# RENESAS TECHNICAL UPDATE

Product Category	MPU&MCU	Document No.	TN-SH7-A726A/E	Rev.	1.00
Title	SH7763 Hardware manual Rev.2.00 corrections		Information Category	Technical Notification	
Applicable Product	SH7763 Group	Lot No.	Reference Document	SH7763 Hardware Manual Rev.2.00 (REJ09B0256-0200)	
		All Lots

We would like to inform valued customers on hardware manual corrections as described below.

## 1. Description correction of Compare Match Timer Control/Status Register (CMCSR) (Page 754)

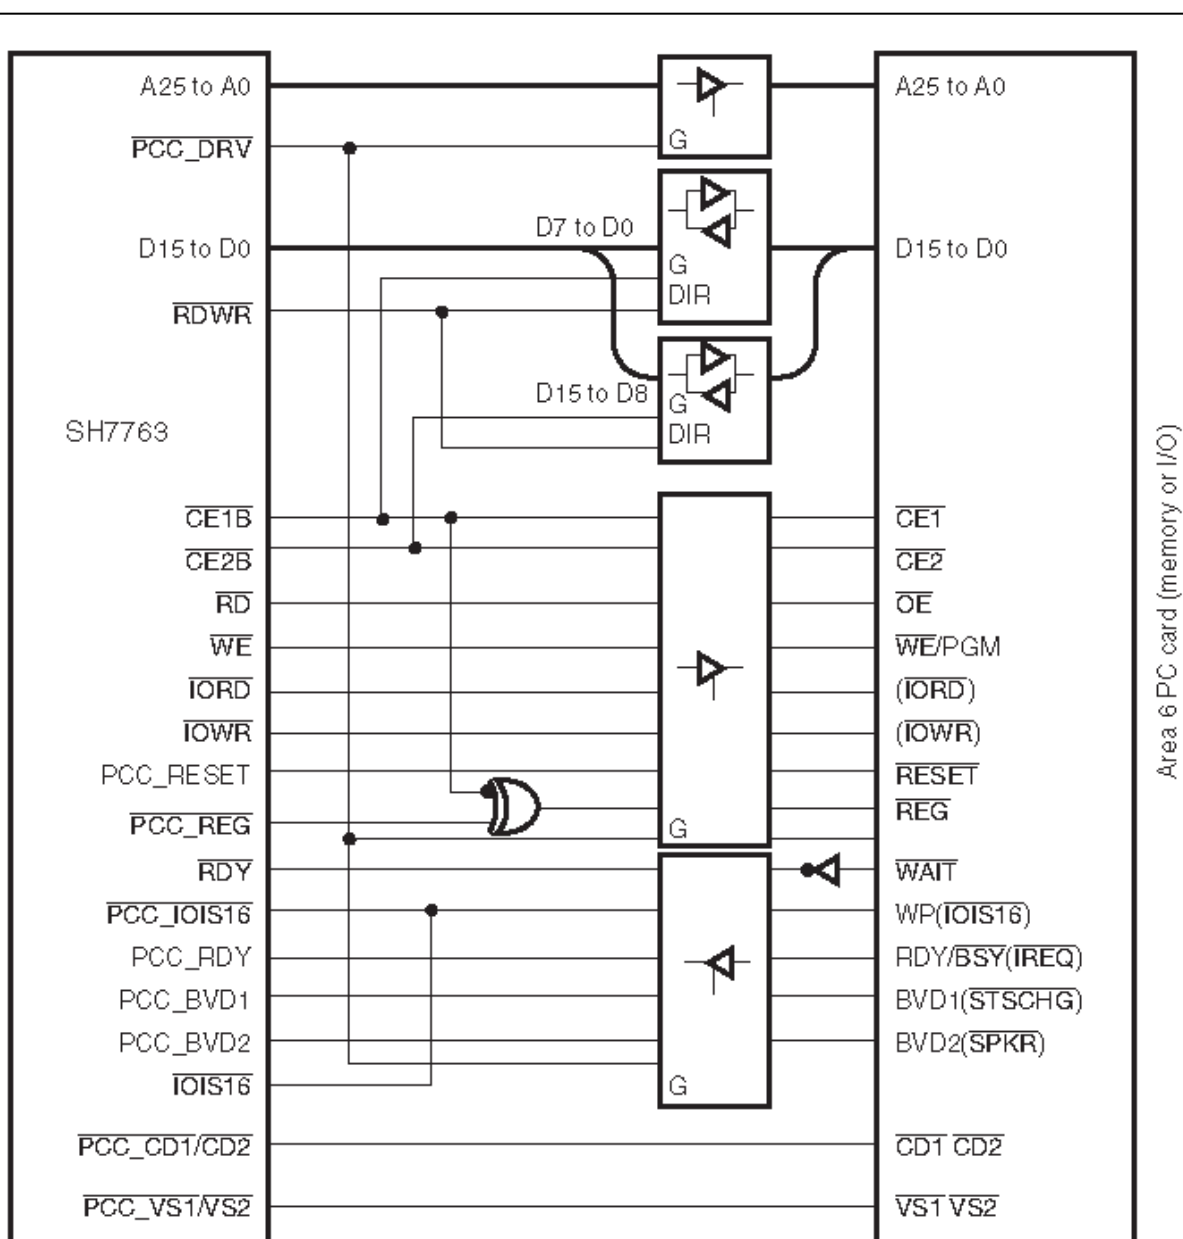
Bit	Bit Name	Initial Value	R/W	Description
15	CMF	0	R/(W)*1	Compare Match Flag This flag indicates whether or not values of the compare match timer counter (CMCNT) and compare match timer constant register (CMCOR) have matched. Software cannot write 1 to the bit. When one-shot is selected for the counter operation, counting resumes by clearing this bit. 0: CMCNT and CMCOR values have not matched [Clearing condition] · Write 0 to CMF after reading CMF=1 1: CMCNT and CMCOR values have matched
14	OVF	0	R/(W)*1	Overflow Flag This flag indicates whether or not the compare match timer counter (CMCNT) has overflowed and been cleared to 0. Software cannot write 1 to this bit. 0: CMCNT has not overflowed [Clearing condition] · Write 0 to OVF after reading OVF=1 1: CMCNT has overflowed

Bit	Bit Name	Initial Value	R/W	Description
15	CMF	0	R/(W)*1	Compare Match Flag This flag indicates whether or not values of the compare match timer counter (CMCNT) and compare match timer constant register (CMCOR) have matched. Software cannot write 1 to the bit. When one-shot is selected for the counter operation, counting resumes by clearing this bit. 0: CMCNT and CMCOR values have not matched [Clearing condition] · <u>Write 0 to CMF</u> 1: CMCNT and CMCOR values have matched
14	OVF	0	R/(W)*1	Overflow Flag This flag indicates whether or not the compare match timer counter (CMCNT) has overflowed and been cleared to 0. Software cannot write 1 to this bit. 0: CMCNT has not overflowed [Clearing condition] · <u>Write 0 to OVF</u> 1: CMCNT has overflowed

Figure 32.4 SH7763 Interface

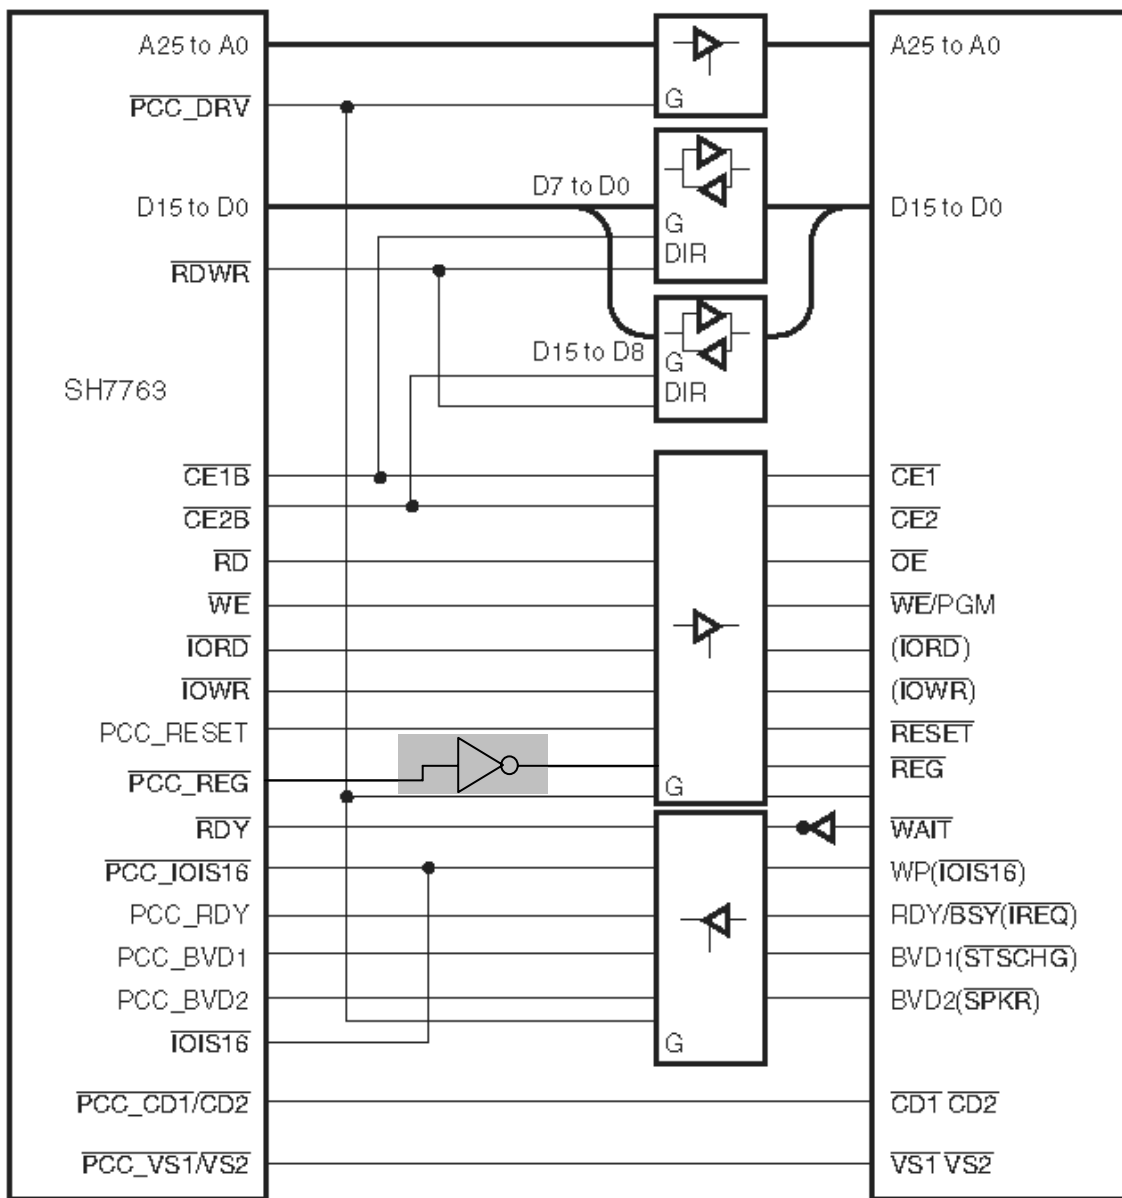
2. PC card Connection Specification (Interface Diagram, Pin Correspondence) (Page 1382)

Figure 32.4 SH7763 Interface (When PCC0GCR.P0USE=1)

Figure F.1 Package Dimensions (449-Pin)

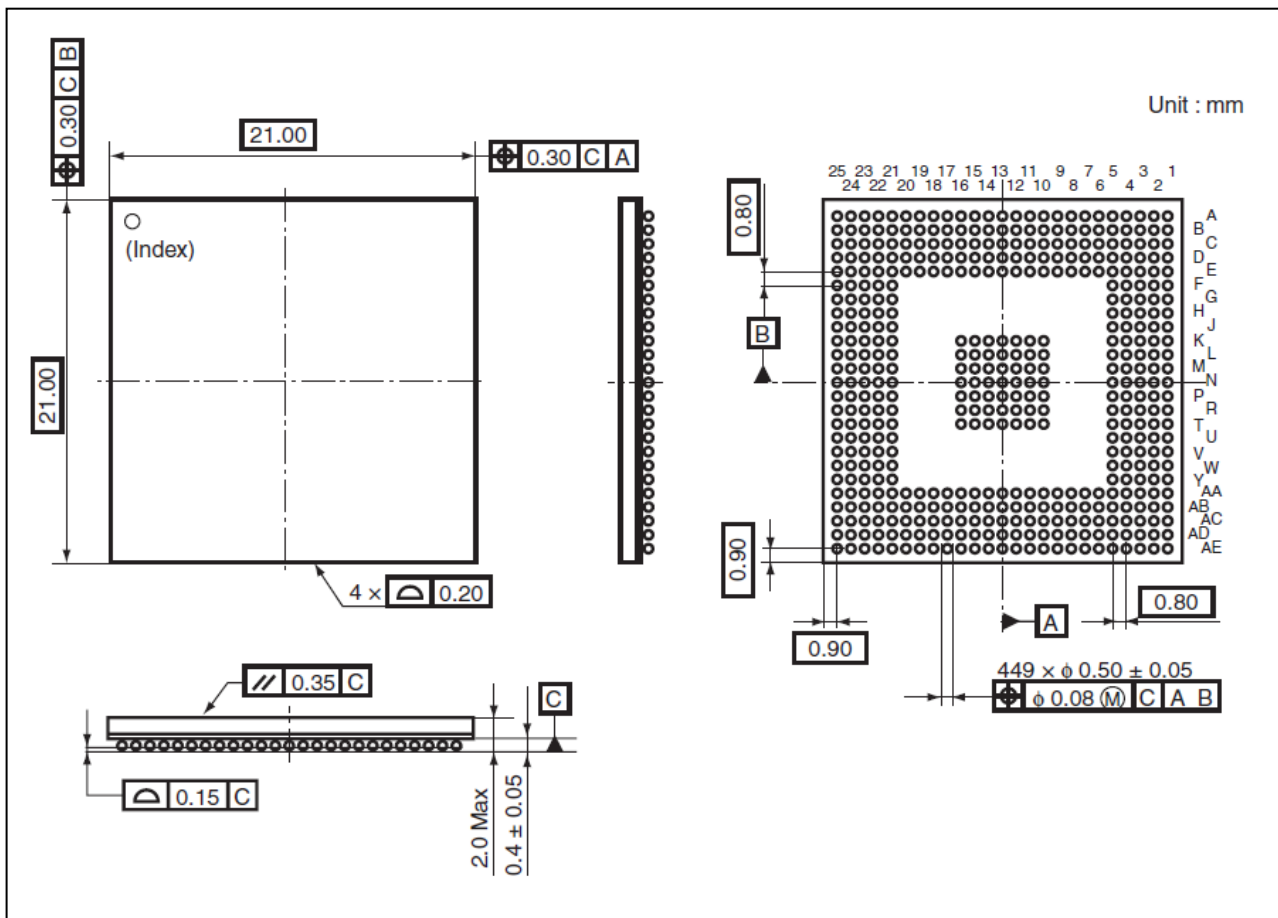
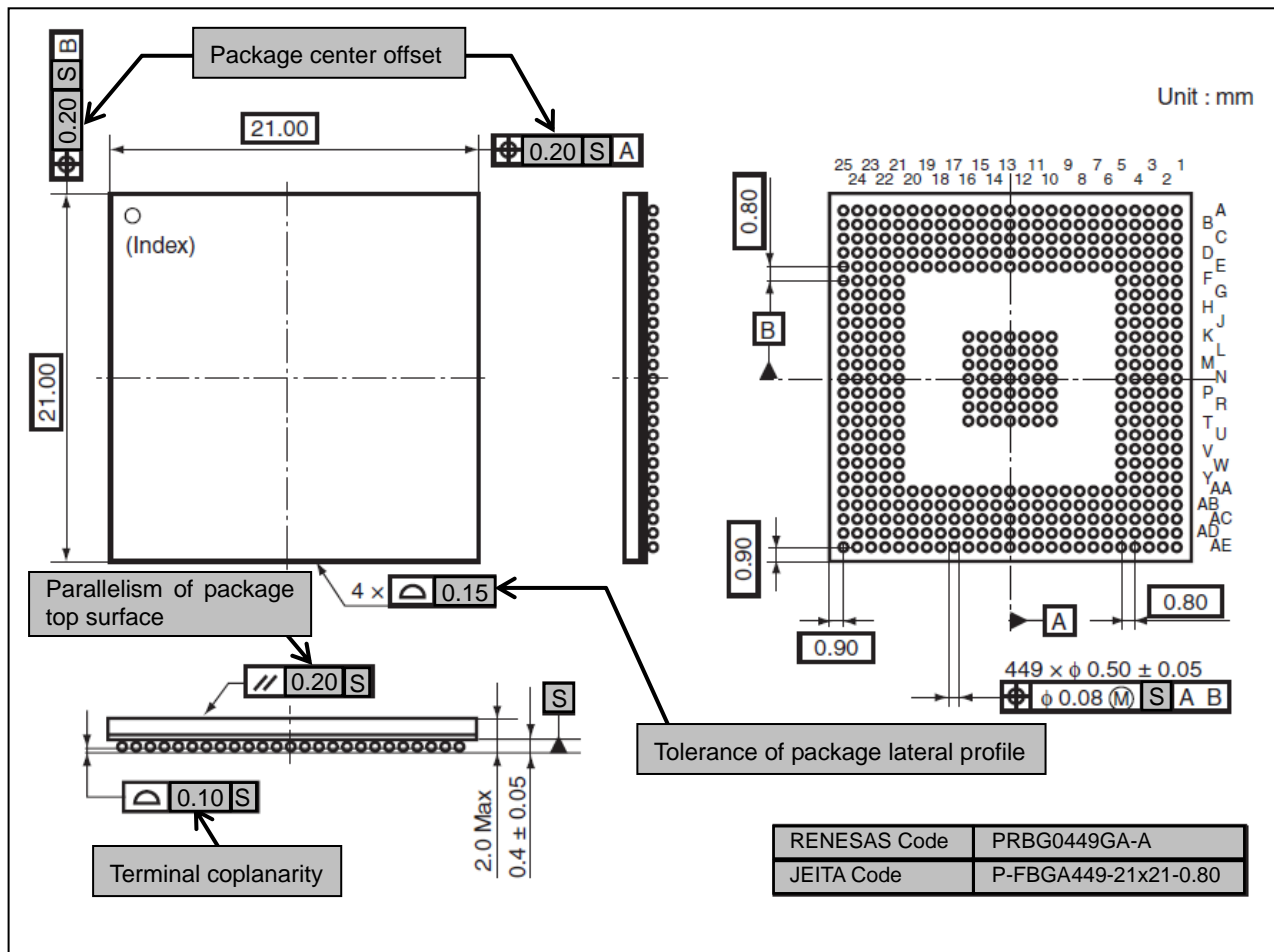
4. Correction of Package Dimensions (Page 1914)

Name	Reference symbol	Symbol	Datum			Before correction	After correction	Unit
			1st		2nd			
			Before correction	After correction				
Package center offset	w	$\oplus$	C	S	A	0.30	0.20	mm
			C	S	B	0.30	0.20	mm
Parallelism of package top surface	y1	//	C	S	—	0.35	0.20	mm
Tolerance of package lateral profile	v	$\bigcap$	—	—	—	0.20	0.15	mm
Terminal coplanarity	y	$\bigcap$	C	S	—	0.15	0.10	mm
